Copper River Watershed Project

Addendum #2

Addendum No.: 2 (9 pages)	Date Addendum Issued: March 19, 2024
Issuing Office/Point of Contact: Copper River Watershed Project Kate Morse, Program Director P.O. Box 1560 511 First St. Cordova, AK 99574 (907)424-3334 kate@copperriver.org	Previous Addenda Issued: Addendum #1/March 6, 2024
Project: Copper River Watershed Habitat Enhancement Project, Cordova EVOS Sites CAB 1 and CAB 2 (Fish Passage Improvement at Elsner River Tributary) and Cordova EVOS Sites COP 9 and SHER 1 (Fish Passage Improvement at Sheridan River Tributary)	Due date for bids: March 29, 2024 5pm AKST

CORDOVA FISH PASSAGE IMPROVEMENTS
ELSNER RIVER - CAB 1 & CAB 2
CAB 2 STREAM SECTIONS AND DETAILS
CORDOVA, ALASKA

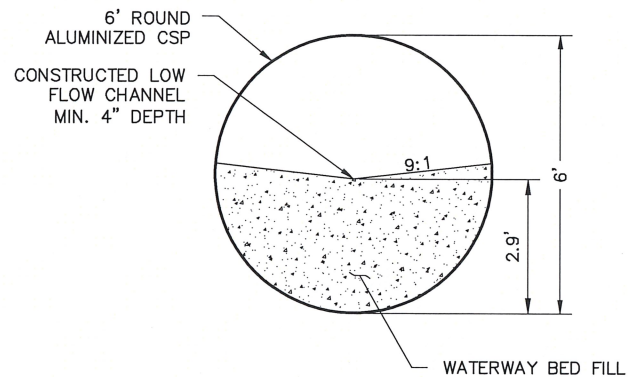
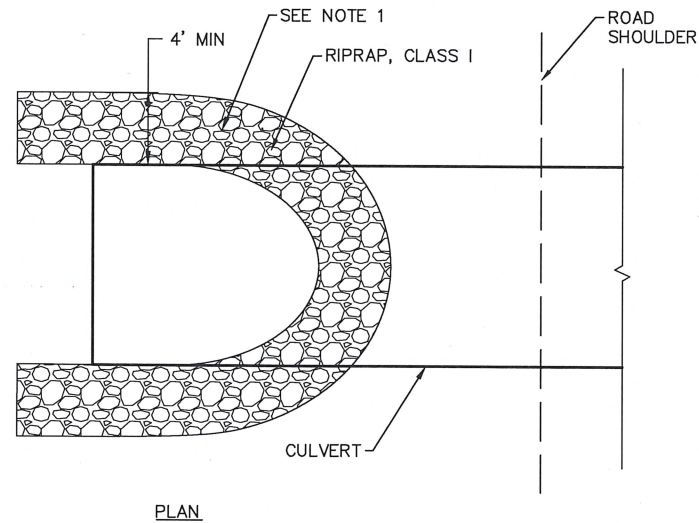
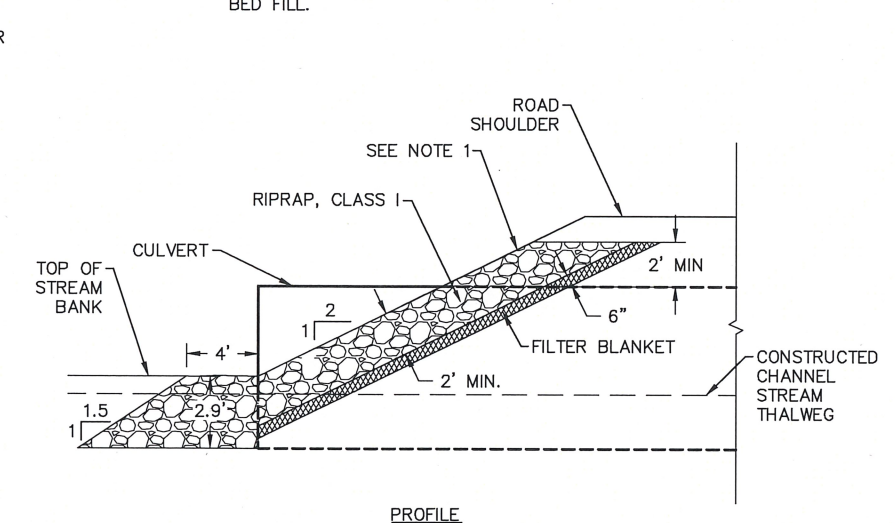
1b	John Baenen, Wilson	Could Sub F be used as porous backfill?	Our preference is to use porous backfill gradation to include more material in the 1 in range.
2	John Baenen, Wilson	Sheet C2: Notes #4 25% 9-inch minus rock(clarification) is this Class 1 riprap? Or is this more like (bonerock from our 13 Mile Pit)?	The material generally follows Class 1 riprap gradation but can be rounded and/or subrounded similar to bone rock.
3	John Baenen, Wilson	In specifications CAB 1 & CAB 2 690-2.01 Waterway Bed Fill 50% selected material, Type C and 50% Riprap Class 1, but in specifications COP 9 & SHER 1 - 690 there is no mention of the specification about material for waterway bedfill except for COP 9, SHER 1 sheet C2 Note 4. The question is are there two different waterway bedfills for COP 9, SHER 1 and CAB 1, CAB 2?	Updated CAB 1/2 Waterway Bed Fill material to match material shown in COP 9/SHER 1. Updated C2 and C9, Section 690-2.01 of Specifications (pg. 36, bold text)

REV	DATE	DESCRIPTION	BY
1	3/18/24	UPDATE TO WATERWAY BED FILL MATERIAL

1. MIX MATERIAL FOR WATERWAY BED FILL TO ACHIEVE A WELL GRADED MIXTURE.
2. FILL VOIDS IN RIPRAP FOR WATERWAY BED FILL. MIX RIPRAP WITH FINES PRIOR TO PLACEMENT AND WASH FINES IN AFTER PLACEMENT.
3. PLACEMENT AND SHAPE OF WATERWAY BED FILL SHALL BE COORDINATED WITH HABITAT PERSONNEL (CRWP OR USFWS OR ADF&G) ON SITE.
